Amendment 39-4172; **AD 81-16-04**

Airworthiness Directives; BELLANCA AIRCRAFT CORPORATION Models 8KCAB, 7ECA, 7GCAA, 7GCBC and 7KCAB Airplanes

81-16-04 BELLANCA AIRCRAFT CORPORATION: Amendment 39-4172. Applies to Models 8KCAB, 7ECA, 7GCAA, 7GCBC and 7KCAB airplanes certificated in Acrobatic category.

FIGURE I
AD 81-16-04

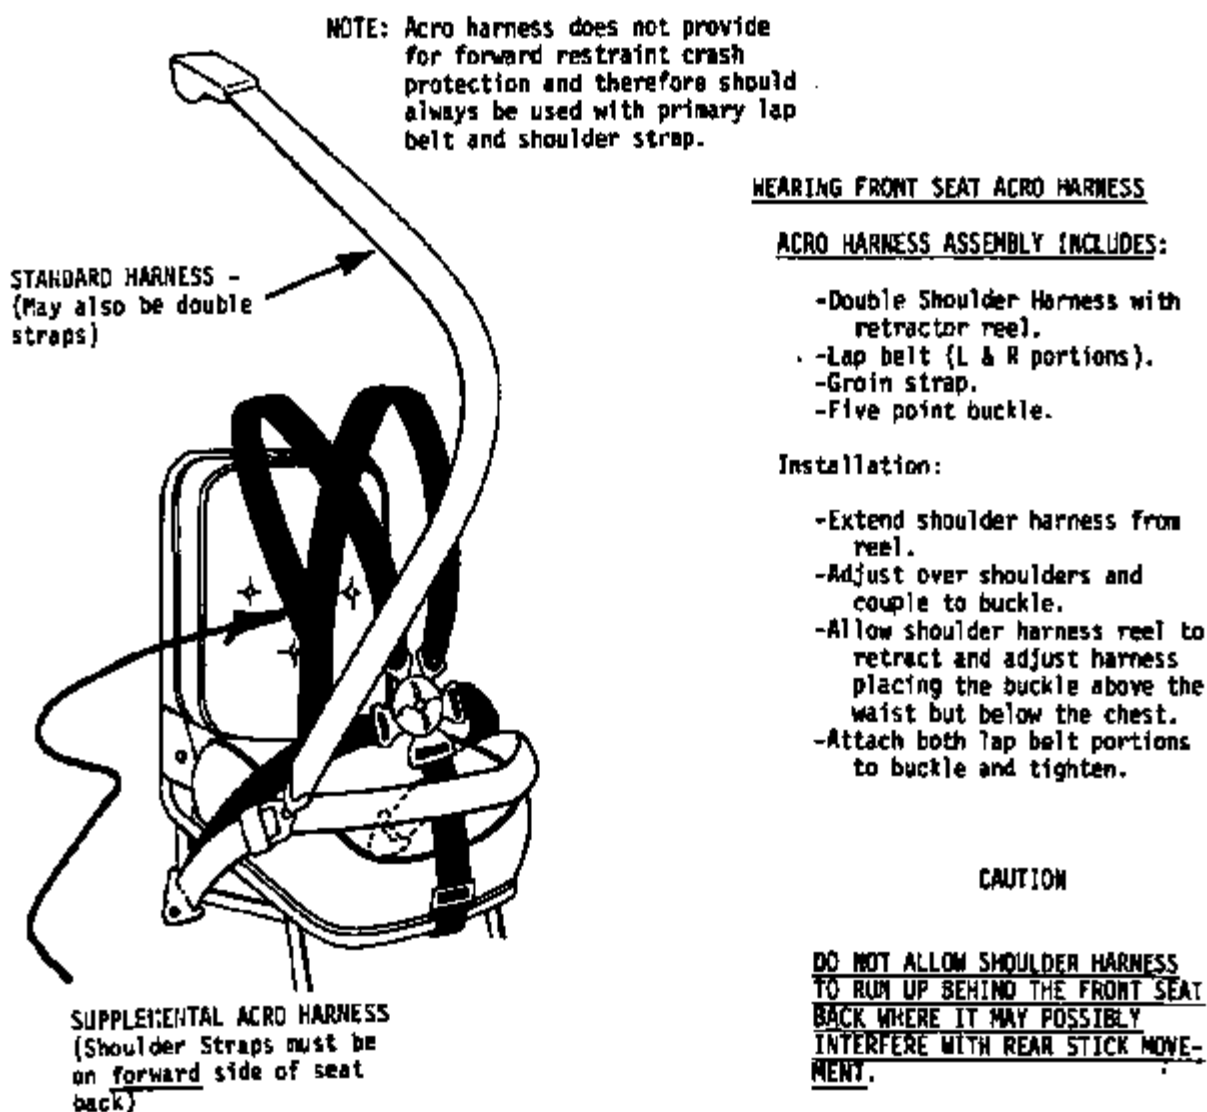
3. Inspect all competition harness installations to insure that the shoulder straps are installed in accordance with figure I of this AD. Insure that the shoulder straps of the added harness pass on the forward side of the seat back.

1. Unless previously accomplished, insert figure I of this AD into all applicable aircraft having approved flight manuals.

2. Attach figure I of this AD to all "Operating Limitation Instructions" (yellow card) for those applicable aircraft where a flight manual is not required (Model 7 Series airplanes).
